INDEPENDENT EXPERT ADVISORY PANEL FOR MINING

REPORT TITLED:

***Metropolitan Coal Mine:
Independent review of environmental
performance to 2022***

Report No: IEAPM 202309-2

Figure 1: Reproduction of Figure 1 of the Dupen Report in which it is captioned as *Key features discussed in this report, annotated in green over base figure reproduced from Metropolitan Coal 2021 Annual Report*, with the blue text boxes being added by the Panel.

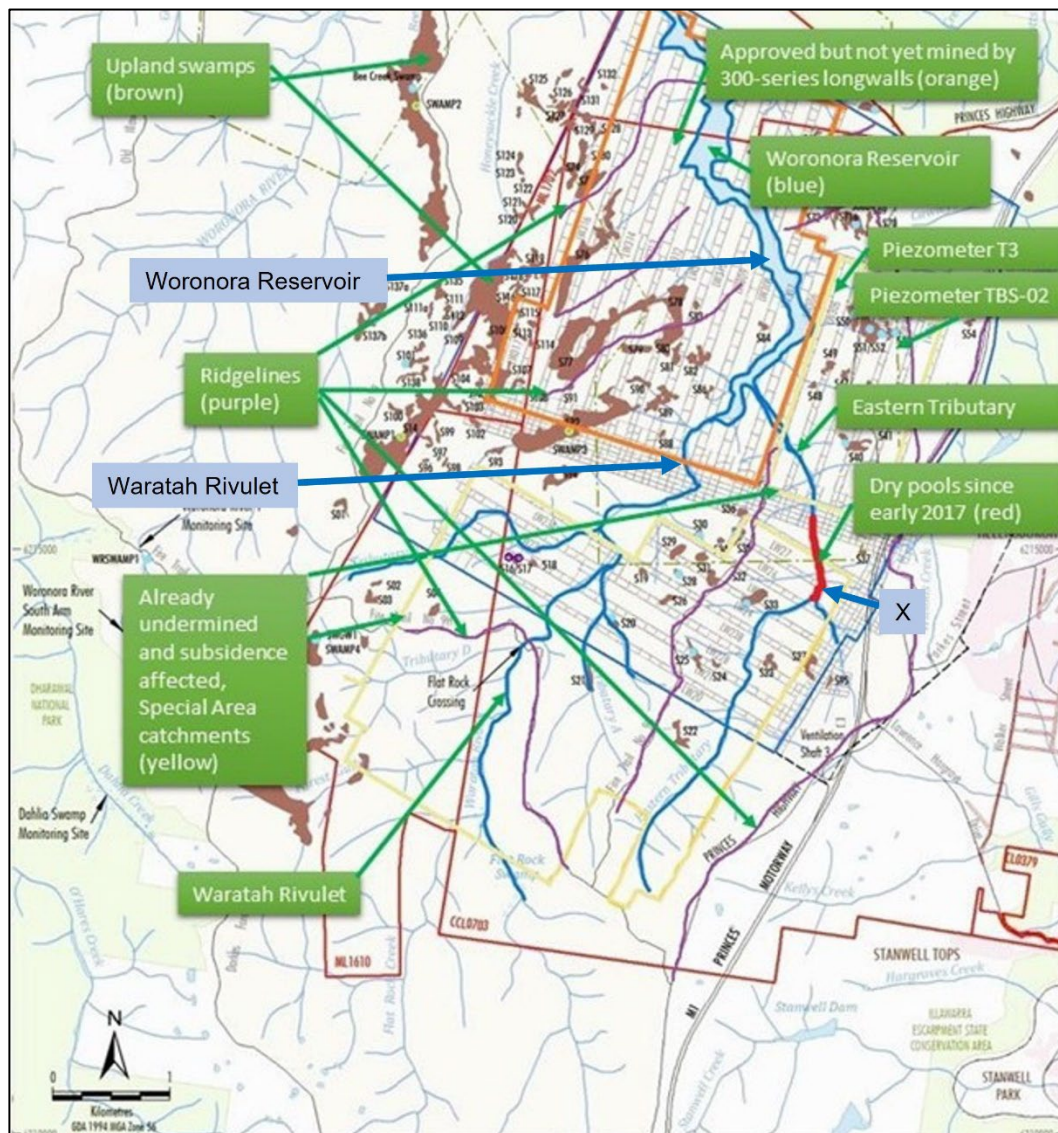
This 500 m section of the Eastern Tributary is the section that has been marked in ‘red’ by Dupen in Figure 1.

The Dupen Report proposes that the drying of pools over a 500 m length of the Eastern Tributary (Figure 1) supports the ridge fracture drainage hypothesis²⁹. This is based on the concept in Figure 6 that water is diverted from the ridges and hillsides through vertical fractures and shear planes into the fractured zone below the creek. The Report includes the statements *‘This evidence includes the unpredicted drying of all pools along a partly undermined section of Eastern Tributary’*³⁰ and *‘Since 2017, the previously permanent Pools ETAG to ETAR (Figure 11) have been dry except for short periods following major rainfall events’*³¹.

Contrary to Peabody's interpretation, my conclusion from the review reported herein is that a diversion of around 500 m of virtually all surface water flows via subsurface channels (Figure 1) constitutes more than a negligible environmental consequence, and therefore an exceedance of the Performance Measure

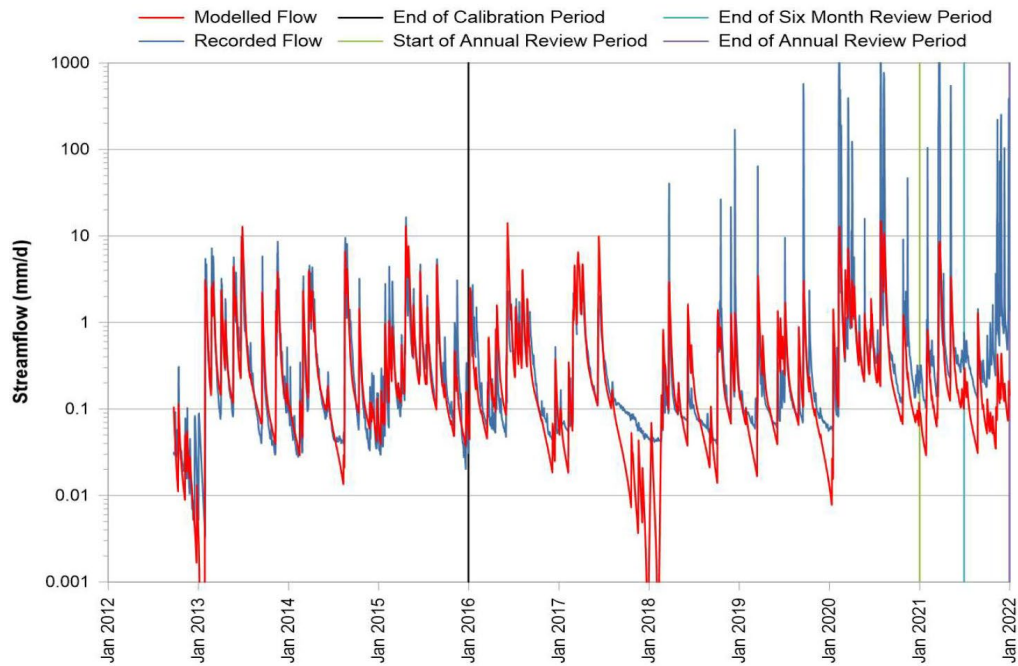
The Dupen Hypothesis¹ has its primary basis in Figure 3, which is Chart 3 of the Metropolitan Coal 2021 Annual Review (Peabody, 2022b). Dupen has concluded on the basis of this chart that during the reporting period (1/1/21 to 31/12/21), flow in Eastern Tributary has been increasingly higher than model predictions².

The Panel does not agree with the reasoning presented by Dupen because the comparisons of catchment flow responses in his Figure 12, reproduced as Figure 3 of this advice report, are based on observed and modelled daily flows. The modelled flows are derived using the Australian Water Balance Model (AWBM), which is a spatially lumped catchment model. Neither this model nor the use of daily flows are designed to simulate local (500 m scale) effects on flow travel times, and so Figure 12 in the Dupen Report should not be used to support or challenge the “tunnel” concept. The Report goes on to state *“I also struggle to identify a plausible mechanism for the increasing flows observed since about October 2021 using this conceptual model”*. While other mechanisms can be identified to explain the increasing flows, no mechanism has been validated to explain the increased flows at this stage. The increased flows need to be better understood, as has been partly addressed by HEC (2022) and commented on by the Panel in Section 5.2.2.

Figure 4: Piezometric data for Boreholes T1 to T6 extending from the reservoir along a transect approximately at right angles to the reservoir. (Reproduction of Figure 9 in the Dupen Report)³

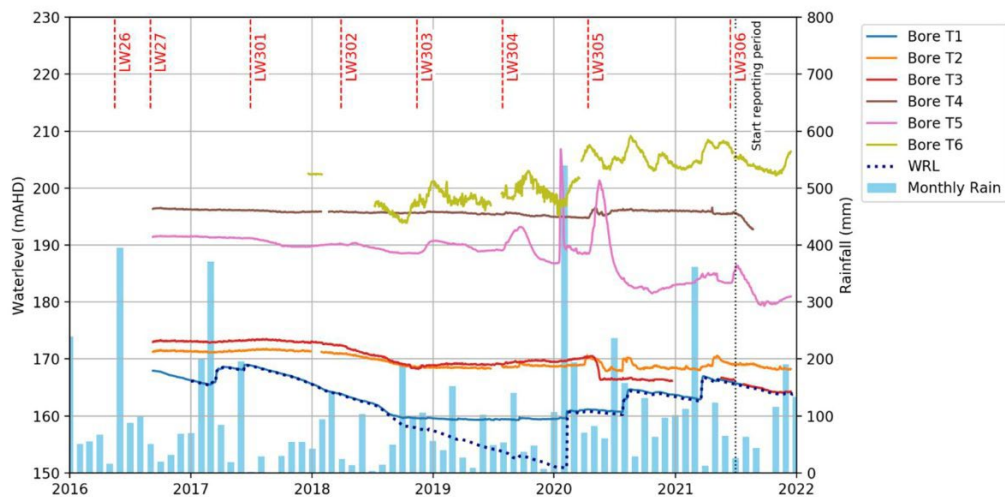
Dupen introduces other lines of evidence for his hypothesis. Of particular significance are the changes in piezometry observed in the transect boreholes T1 – T6, shown in Figure 4. The location of the transect can be identified from Figure 1 by the positioning of piezometer T3.

There are numerous concerning aspects of the post-mining groundwater conditions revealed by the transect piezometers. These include the long-term anomalously low water table in T5 (Figure 8 and Figure 9) and recent drops in T4 and T5 levels. Another surprising feature are the three large (+10 m) observed level surges in T5 between mid-2019 and mid-2020 (Figure 9), which are reasonably attributed by Peabody's consultants to pressure waves affecting the aquifer as the longwalls progress beneath. If present however, any pressure waves felt at T5 should intuitively have been observed at all of the nearby wells, especially the adjacent T4 piezometer (Figure 3). The reason for this contrast in pressure wave response through the

The most disturbing trend however, is that the levels in T3 dropped below its base 17 days after the commencement of Longwall 305 (Figure 3), and then sheared in December 2020 (Figure 9). The piezometer was replaced in 2021 by a deeper one at the same location (T3-R). As can be observed by the red trace in Figure 9, groundwater responses in T3/T3-R appeared sensible for its ridge position prior to mining but now the water table closely mimics the reservoir level.

Figure 6. Reproduction of Figure 4 of the Dupen Report where it is described as *Schematic showing the hypothesised causes of “ridge fracture drainage”, annotated here as basal shear planes (yellow) and sub-vertical stress relief fractures (grey).* Base figure reproduced from *Advisian, 2016*

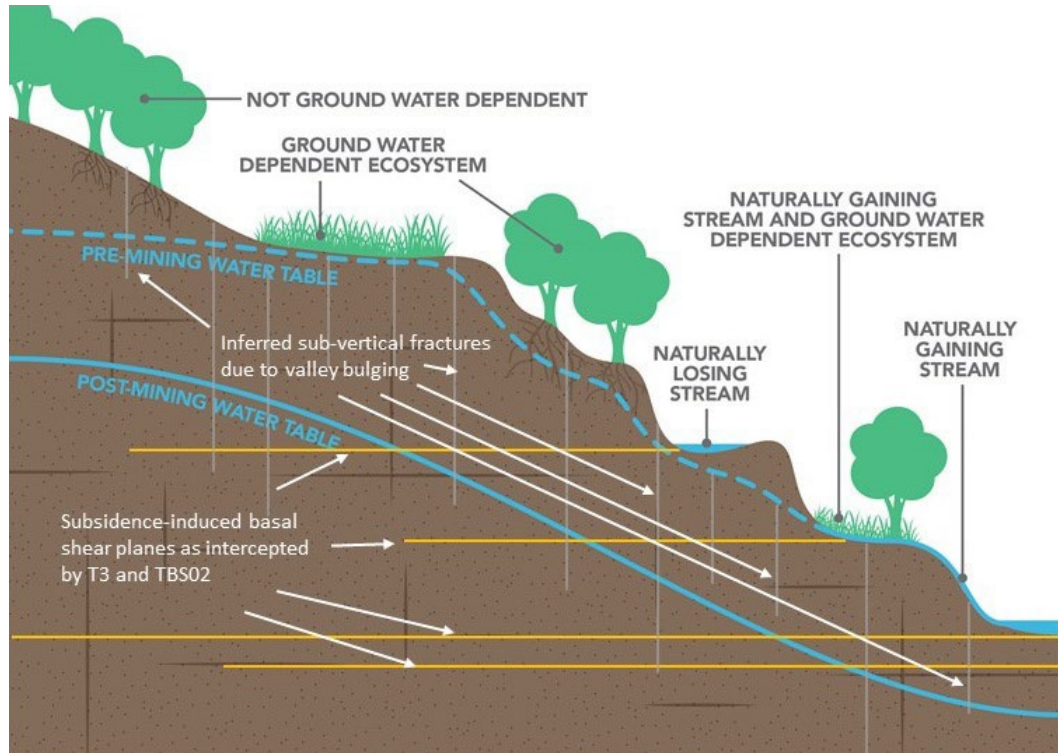
Figure 4 of the Dupen Report (reproduced as Figure 6 of this advice report) is a schematic that represents most of the perched and regional groundwater flow and discharge processes that occur in the Hawkesbury Sandstone landscape across the Southern Coalfields. However, the schematic is not representative of the specific groundwater processes that are occurring in the Eastern Tributary catchment. The schematic shows:

The caption to Figure 4 of Dupen (2023) refers to the inferred sub-vertical fractures as being *stress relief fractures*. As the valley sides are not subjected to lateral stress, stress relief is not a plausible mechanism for inducing vertical cracking. However, sub-vertical fracturing can be associated with conventional subsidence (subsidence troughs) and with unravelling of slope material caused by subsidence movement, although these fractures tend to close. This is because surface alluvium and rock displace downhill under the effect of gravity, resulting in tensile strains accumulating towards ridge tops and being expressed as wide, open cracks. For example, Galvin (2005) reported the presence of a +200 mm wide crack on a fire trail at the top of the ridge above Waratah Rivulet.

Against this background, subsidence can be expected to increase the capacity of the surface to absorb rainfall, however, the distributions and depth of the inferred subvertical fracturing shown in Figure 4 of the Dupen Report (Figure 6 of this Panel Advice report) is considered highly conceptual and very unlikely to represent the situation in the field.

Figure 4 in the Dupen Report, reproduced as Figure 6 of this advice report, and associated explanations in Sections 3.2 and 3.3 of the Dupen Report are an over-simplification of the groundwater flow processes in the Waratah Rivulet and Eastern Tributary catchments.

Figure 9: Profiles of predicted valley closure along the Eastern Tributary associated with both the mine layout proposed in the EIS for the Metropolitan Coal Project and the modified layout presented to the PAC during its assessment process (Peabody, 2009).

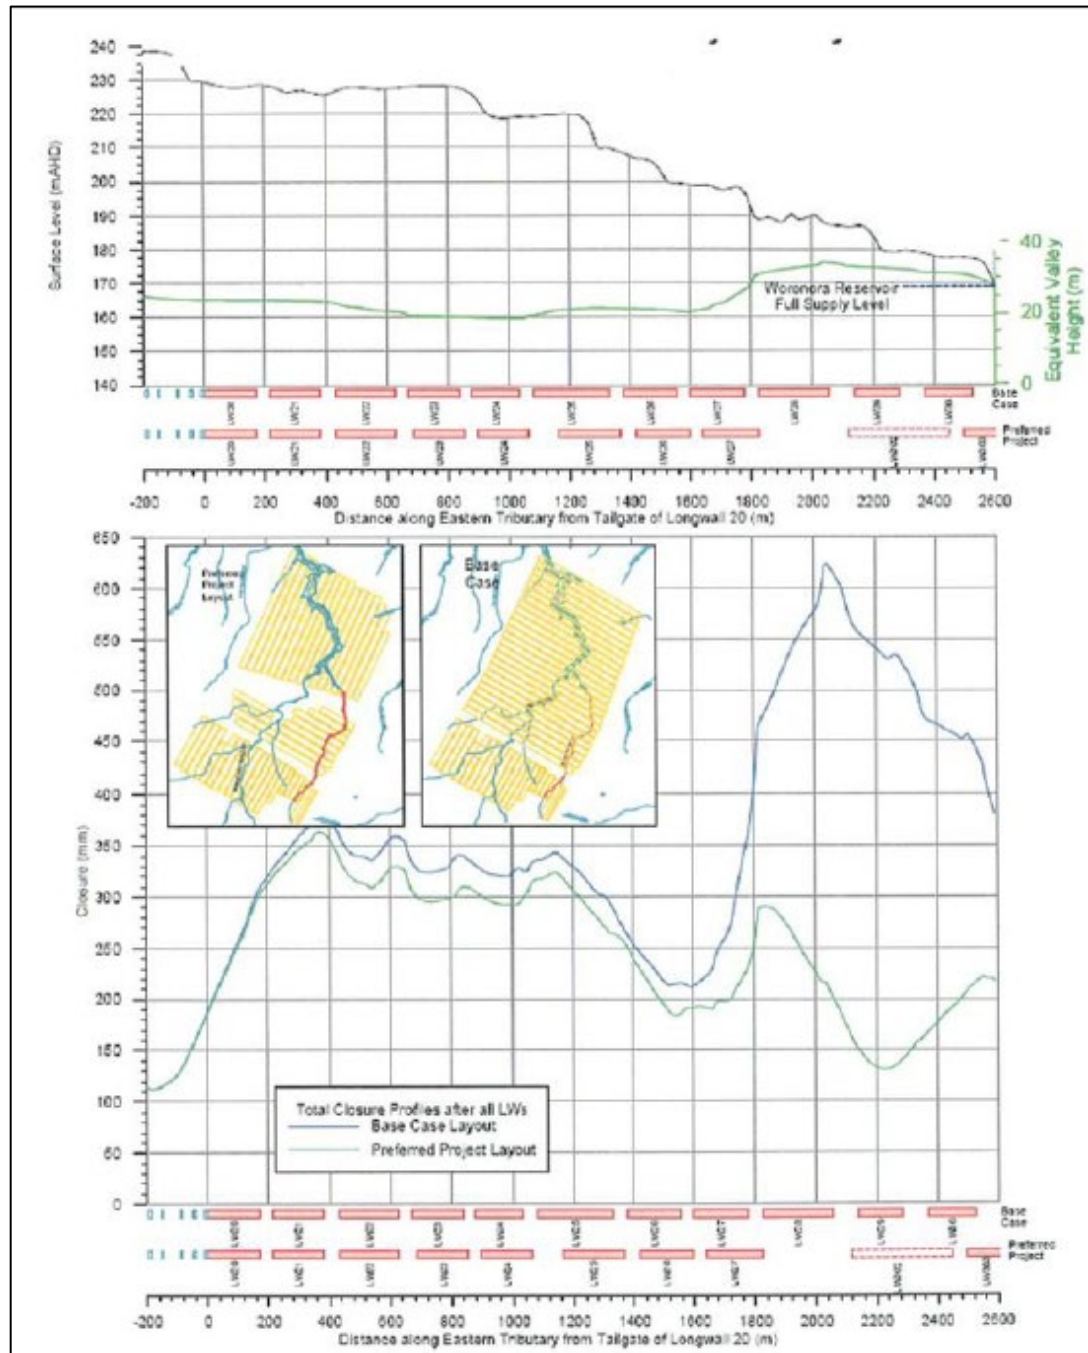
The revised mine layout was based on limiting predicted valley closure along Waratah Rivulet to less than 200 mm. However, this in turn did result in a reduction in predicted valley closure along the Eastern Tributary, as shown in Figure 9.

An expanded version of the PPR was submitted to the Department of Planning (DoP) after the PAC had concluded its review (as reported in the Department's 'Reasons for Approval'). However, the mine plan and predictions of valley closure were basically unchanged from that shown in Figure 9. DoP stated in its assessment of the PPR that:

LW27 was completed in March 2017 and mining of LW301 commenced in June 2017. This panel was shortened for operational reasons and, as shown in Figure 10, stopped over 350 m short of its planned finish point. Hence, the contribution of this panel to cumulative valley closure along the Eastern Tributary could be expected to be minimal. LW302 was extracted to its originally planned and finished in February 2018. Soon after, it was recognised that the Performance Measure of negligible for 70% of the length of Eastern Tributary downstream of Point X had been exceeded, resulting in LW303 to LW305 being setback from Eastern Tributary substantially greater distances than planned at the time of project approval. The modified layout, shown in Figure 10, resulted in moderate to very large decreases in predicted valley closure downstream of about pool ETAM²⁵, as evidenced by comparing predictions plotted (in green) in Figure 9 with those tabulated in Figure 10.

Figure 10: Predicted cumulative valley closure at the Eastern Tributary for LW302 to LW308 (Peabody, 2019).

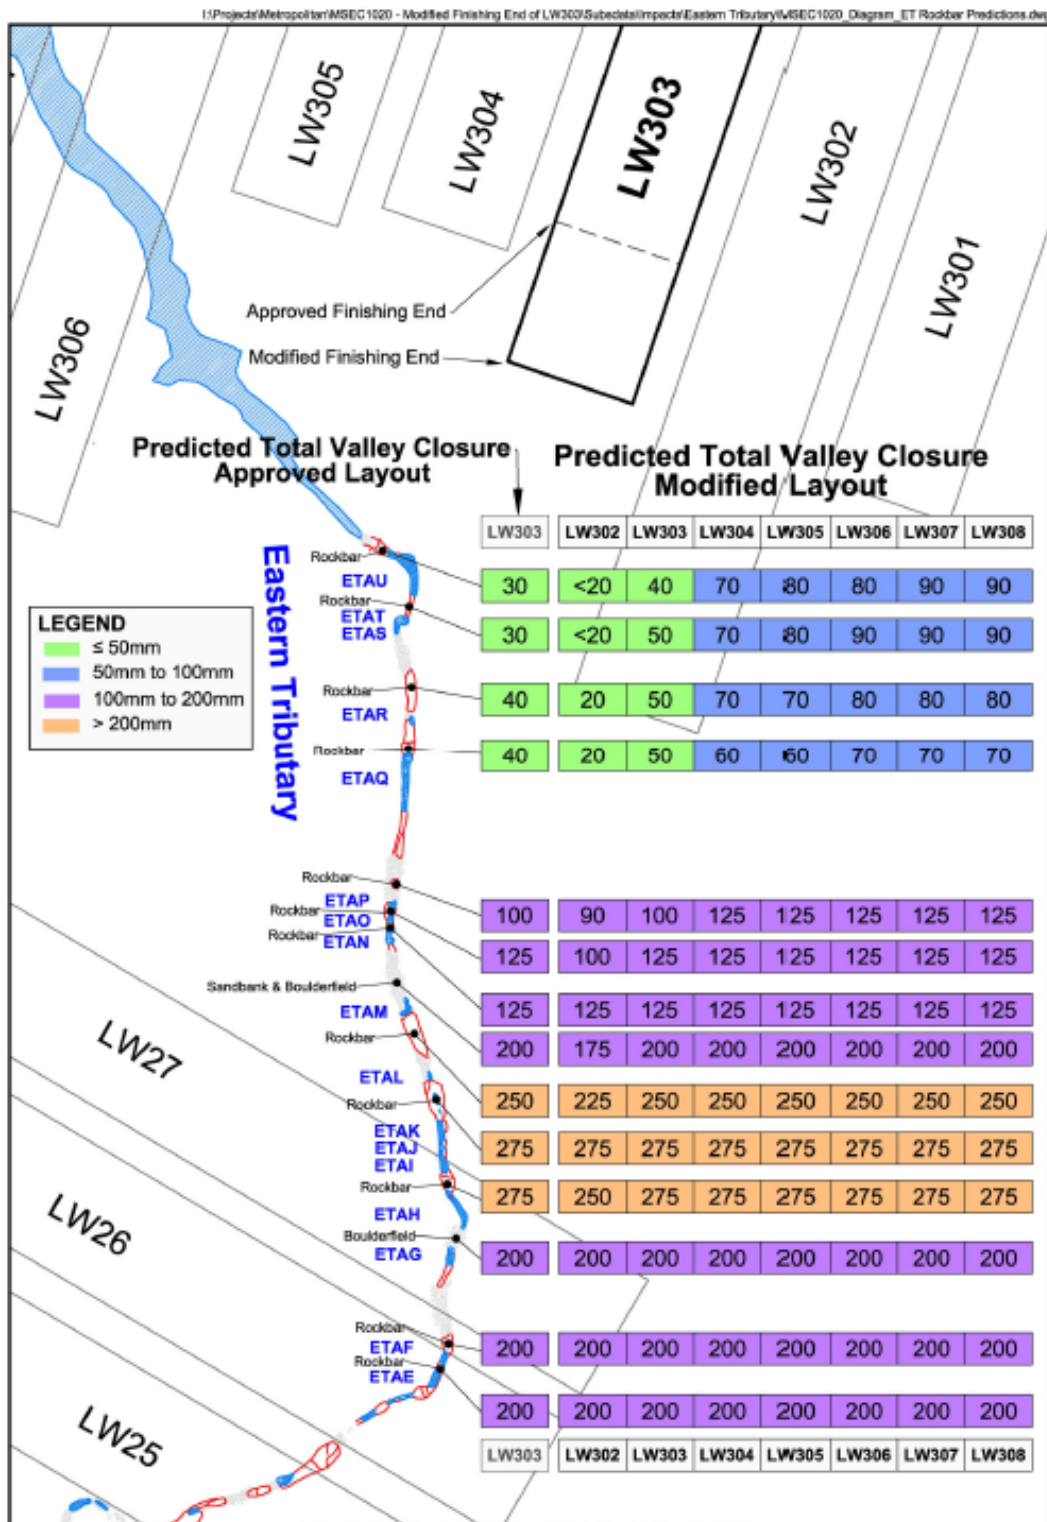
The Panel notes that the Eastern Tributary was undermined by LW27 in November and December 2017 and remained within the area of influence of active mining until the panel was completed in March 2017. The tabulations of predicted valley closure presented in Figure 10 show that after the completion of LW302, predicted valley closure plateaued at 200 mm on the southern flank and at the centre of LW27 and at 275 mm on the northern flank of LW27 and downstream to rockbar ETAL. It then progressively reduced and plateaued at 200 mm at ETAM and 125 mm at ETAN, ETAO and ETAP.

Figure 12: Daily and annual rainfall at the Darkes Forest gauge (approximately 5 km south-west of the Eastern Tributary flow gauge). Data sourced from <https://www.longpaddock.qld.gov.au/silo/>.

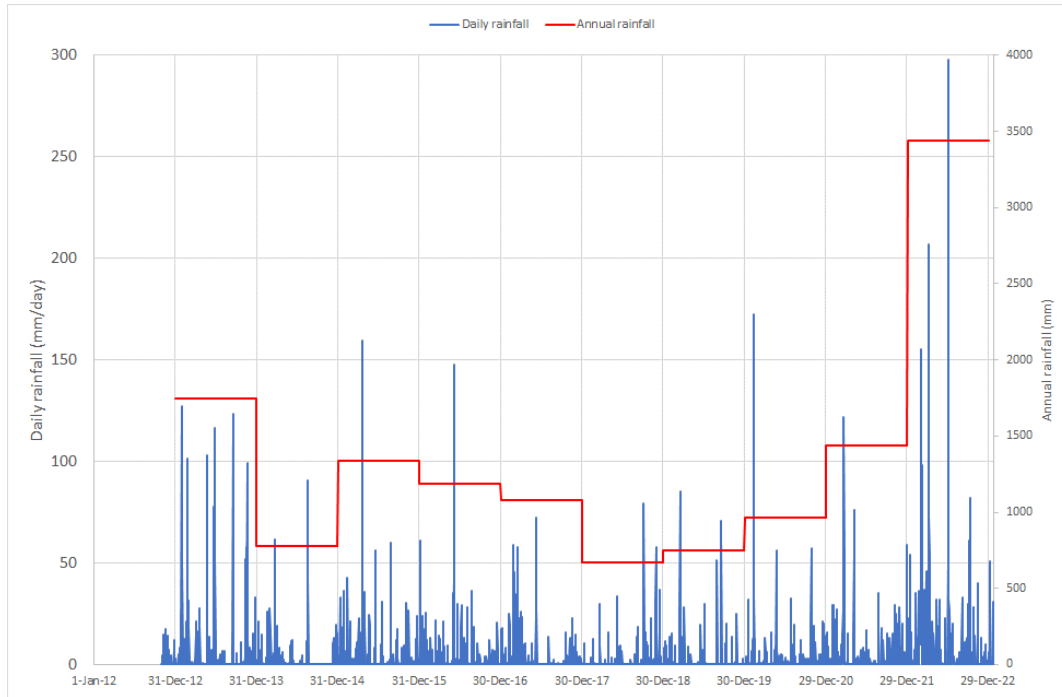
For high flows, from January 2019, Figure 3 includes several incidences of the flow rate measured at the Eastern Tributary weir being well above the rainfall rate at the nearby Darkes Forest gauge, Figure 12, which is implausible.²⁷ Following Metropolitan Coal's investigation into the flow anomalies (HEC, 2022), the rating curve (i.e. the calibration of the flow-depth relation at the flow measurement flume and weir) was updated to give the data in Peabody (2022b) reproduced as Figure 13 in this advice report. Figure 14 (Figure 8 from HEC, 2022) is the same plot, zooming in on the period 1-Jan-2020 to 1-Sept-2022.

The latter statement does not accurately reflect the data, which shows that outside the period of unusually dry weather from 2017-2019 (see Figure 12), the pools were generally flowing in the reported period (2017-2022). This is illustrated in Figure 15 for pool ETAI, which is generally representative of the data for other pools from ETAG to ETAR (as shown in Peabody (2023), Charts 5-12) although pools ETAM to ETAR are less frequently dry during the dry weather of 2017-2019. This shows that weather is the dominant control on pool levels. Nevertheless, mining subsidence consequences on pool levels and drainage at pools ETAG-ETAR have been acknowledged (Peabody, 2023)
